## 4. Additional investigations

#### 4.2.1 Assessment of alternative horizontal and vertical alignment at Cowpasture Road

Figure 4-1 **Alternative horizontal and indicative vertical alignment in vicinity of Cowpasture Road**  
 Source: Connell Wagner (2007)

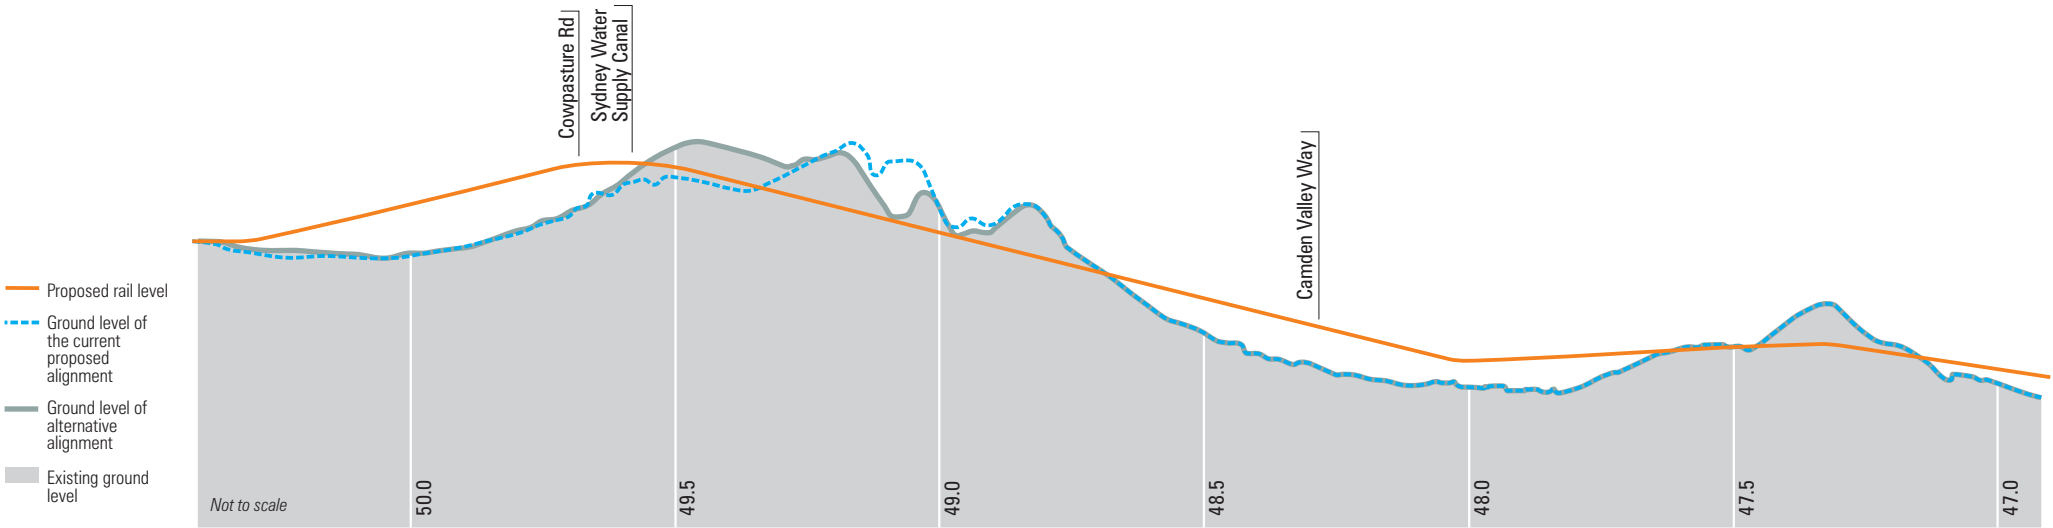
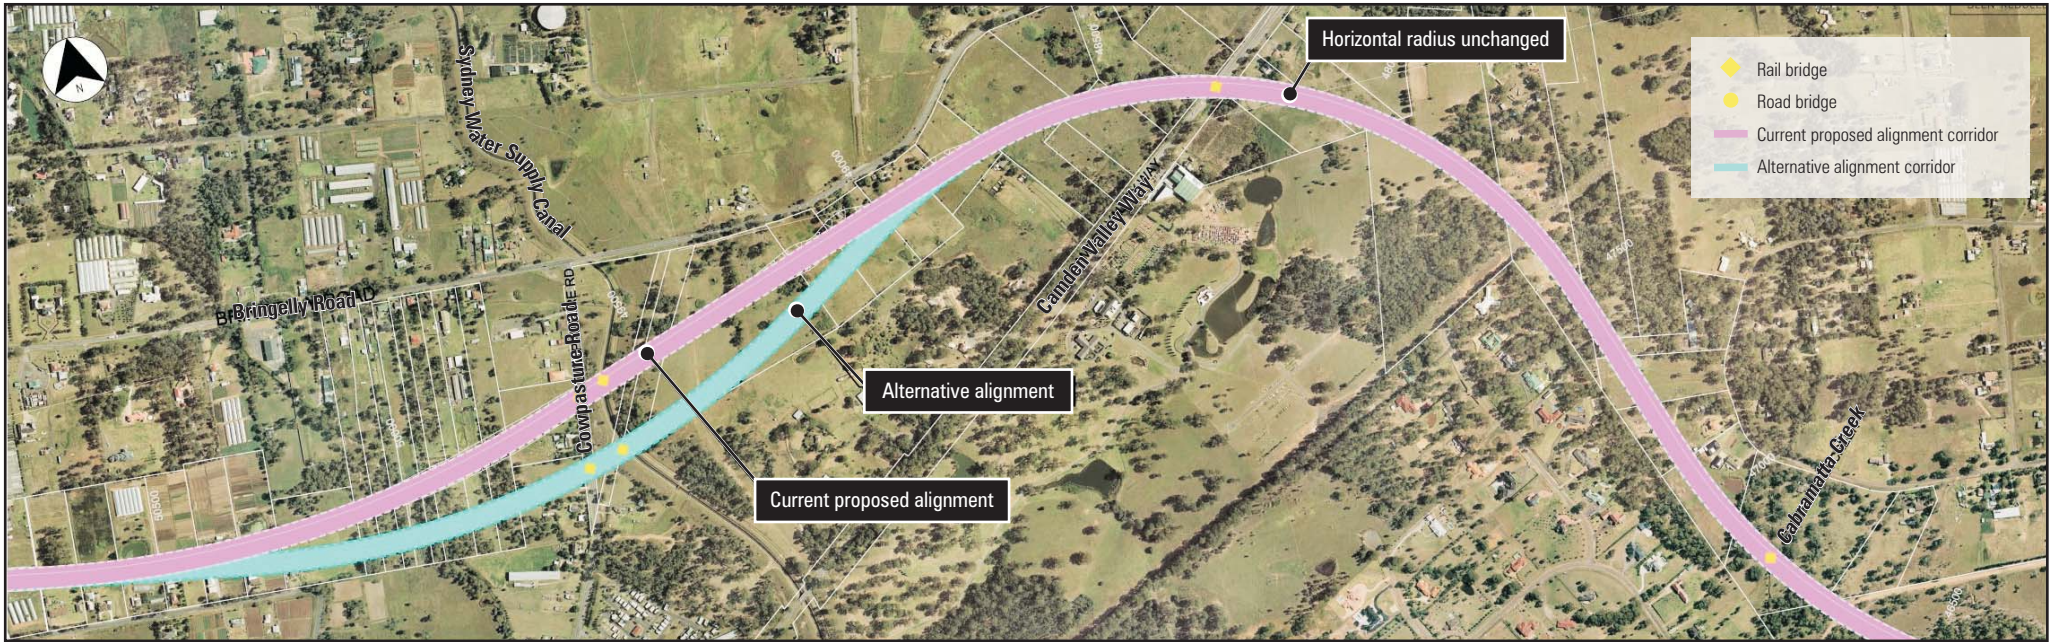
As detailed in Section 3.3, several submissions raised concerns about the visual and other impacts associated with the indicative vertical alignment of the SWRL in the vicinity of Cowpasture Road. A few submissions also requested that TIDC consider moving the alignment further to the south to minimise direct property impacts in this area. Suggestions that the SWRL could pass under Cowpasture Road and the Sydney Water Canal are not considered feasible due to the prohibitive cost of tunnelling, flooding issues, and risks associated with the potential for damage to the canal and the location of the major Sydney to Moomba and Eastern Australian Gas pipelines running adjacent to the canal.

TIDC has, however, undertaken further assessment of an alternative horizontal alignment that was suggested (including lowering of the vertical alignment), which is drawn on Figure 4-1. The alternative is compared with the proposed alignment in Table 4-1.

In consideration of the above, the suggested alternative alignment does not represent a better engineering design outcome at this location or for the SWRL alignment as a whole, nor does it result in any significant reduction in potential visual impacts or amenity. The alternative would not result in any significant lowering of the vertical alignment. The SWRL alignment is not, therefore, proposed to be amended. The management of visual impacts of the embankment through this area would be considered in the further design development and assessment (see SoC B36 in Appendix A).

Figure 4-2 Additional commuter car parking provision, Glenfield Station

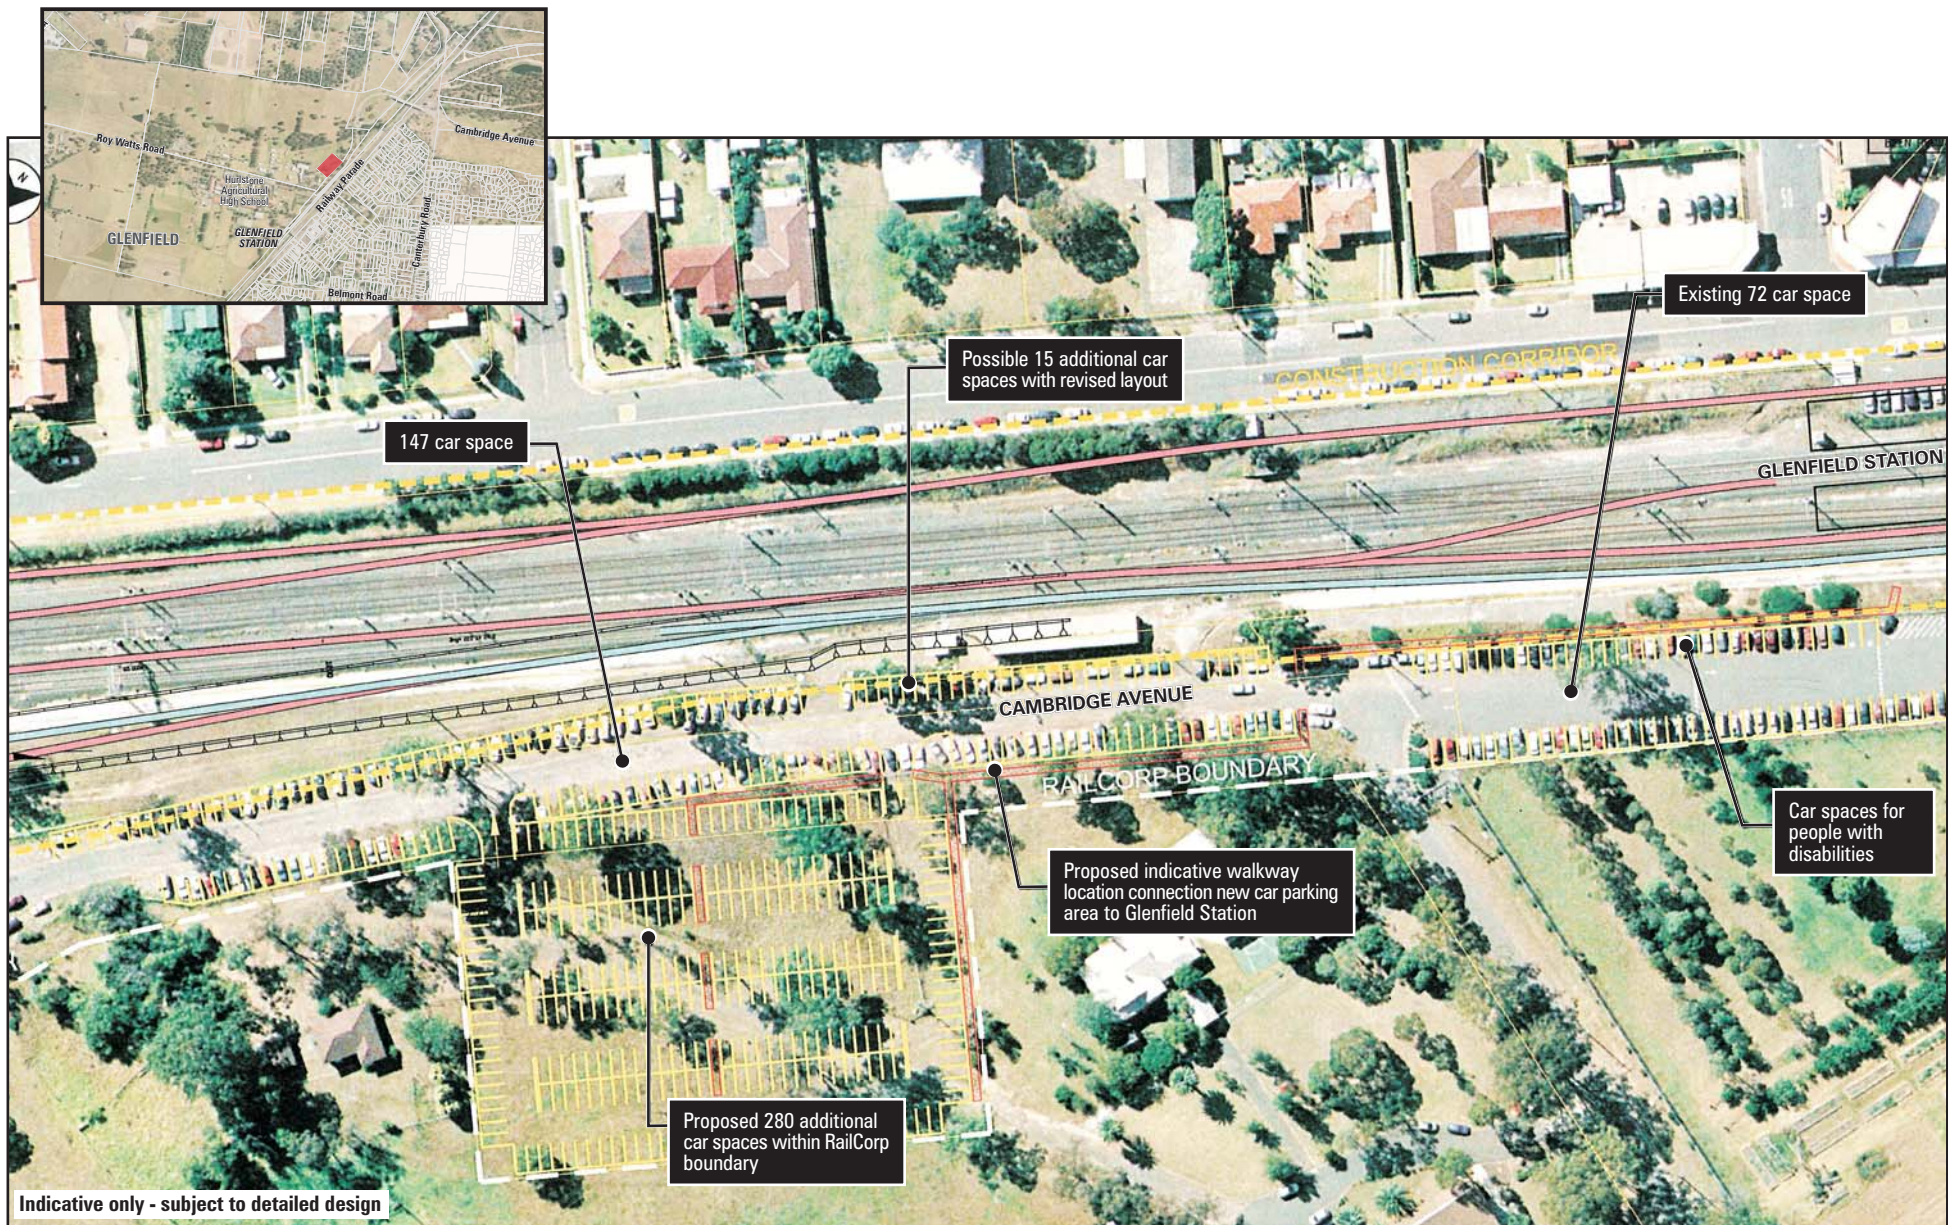
A review was undertaken of the parking provision at Glenfield Station, as a result of submissions received on the issue and the recent release of the NSW Government's (November 2006) Urban Transport Statement that commits to investigation of additional commuter parking at Glenfield. The review considered the form and level of the proposed commuter parking at Glenfield Station in the short term, and whether this could be delivered as part of the planned Stage A works.

TIDC's further investigation of this issue found that:

- Providing at-grade parking on a currently unused parcel of RailCorp land could provide up to 280 additional parking spaces on the western side of the Station (i.e. replace the 120 spaces that would eventually be lost and provide an additional 160 spaces). An additional 15 spaces could be provided along the access road that services the station and school (by reconfiguration of the existing spaces near the access to the RailCorp land). (Note: The existing informal parking arrangements on the access road to the station and school provide 219 spaces.).

Considering the above, together with the NSW Government's (2006a) Urban Transport Statement that undertakes to investigate additional commuter parking in the long term, it was concluded that the best option, in the short term, would be to provide some additional commuter parking at Glenfield Station. This would be best achieved by making use of existing RailCorp land on the western side of the corridor (see Figure 4-2) to construct up to 280 spaces at grade and delivered as part of the Stage A SWRL works to minimise the impacts on commuter car parking arising from the subsequent construction of Glenfield Station (Stage B). The proposed amended arrangement is described further in Chapter 5 - Modifications to the SWRL Concept Plan. The long-term provision of commuter parking would be considered in the SWRL further assessments, as detailed in the SoC B12 in Appendix A.

The site was previously flagged in the EA and Concept Plan (Figure 20-2a). The new car park would be commuter parking (generally all day parking). The proposed concept design (see Figure 4-2) allows for:

- up to 280 additional spaces, with access points to the access road to the station and educational facilities
- spaces for people with disabilities (5 to 15 spaces)
- an allowance for a new walkway to provide access from the new parking area to Glenfield Station.

Figure 4-4 Revised indicative vertical alignment at Eastwood Road

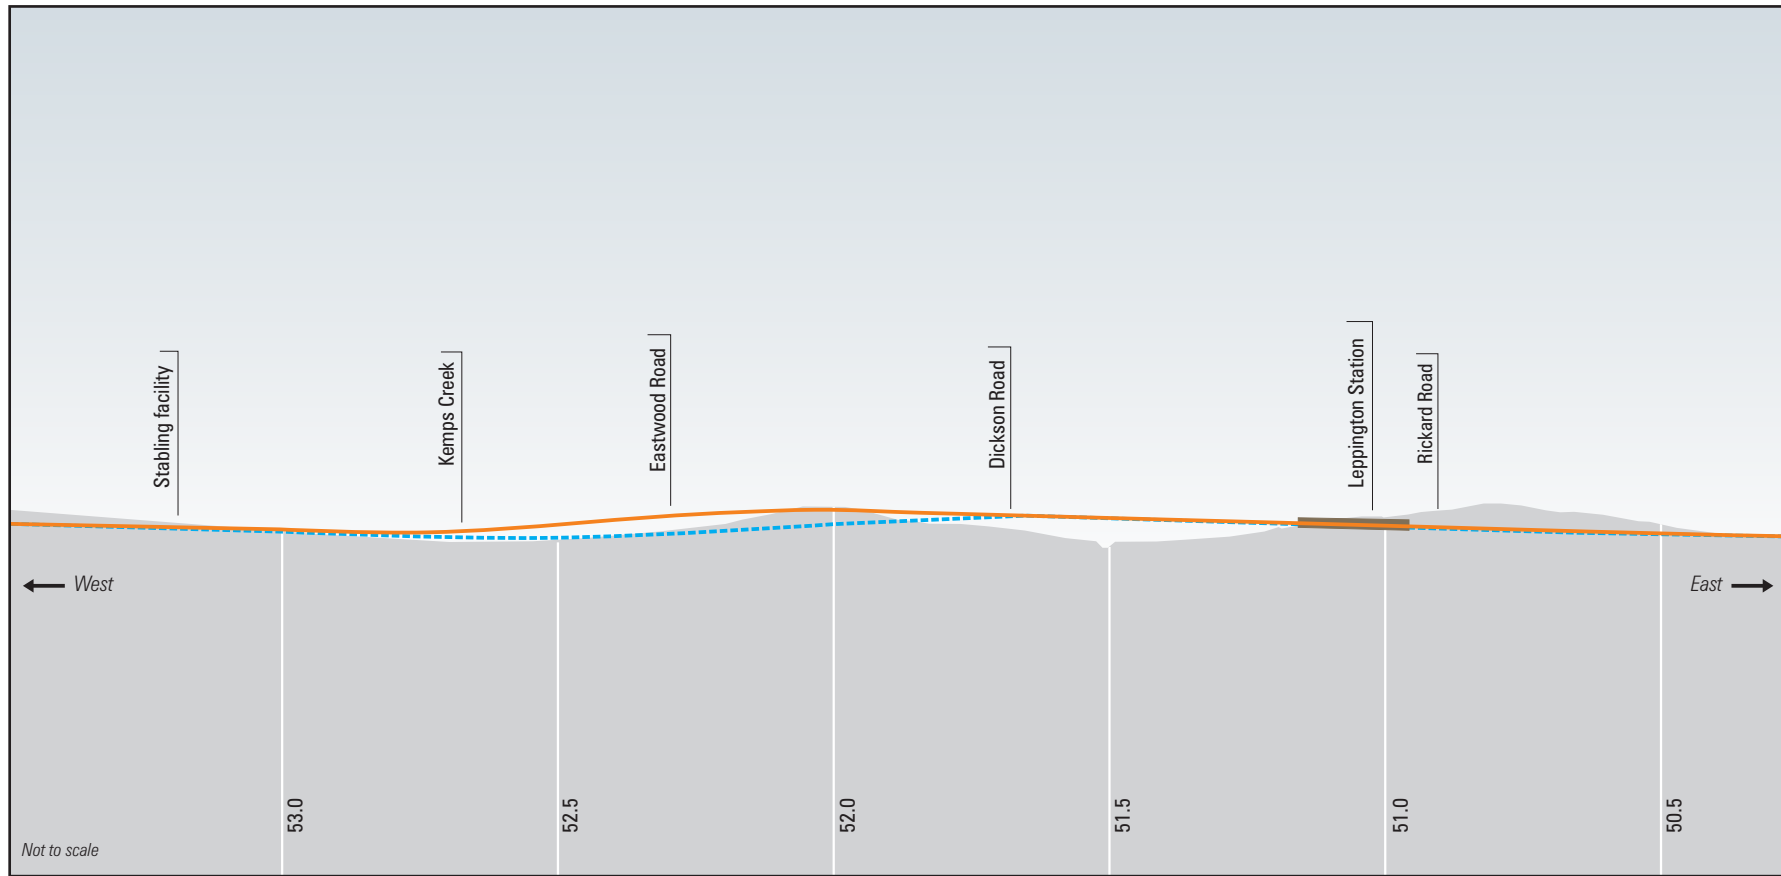
The indicative vertical alignment of the SWRL in the EA and Concept Plan (in Figure 20-2d), showed the SWRL crossing Eastwood Road at grade. To ensure consistency with the South West Growth Centre Structure Plan and minimise conflict between the SWRL and road operations/construction, TIDC further investigated the vertical alignment design in this area. The engineering concluded that the SWRL could pass over Eastwood Road in this area, subject to the confirmation of levels and required clearances during the further design. The revised indicative vertical alignment is shown in Figure 4-4 (including a comparison with the previous vertical alignment).

Amendments to the vertical alignment of the SWRL do not result in any changes to the Concept Plan. As noted within the EA, the vertical alignment is indicative only and subject to further design development and assessment.
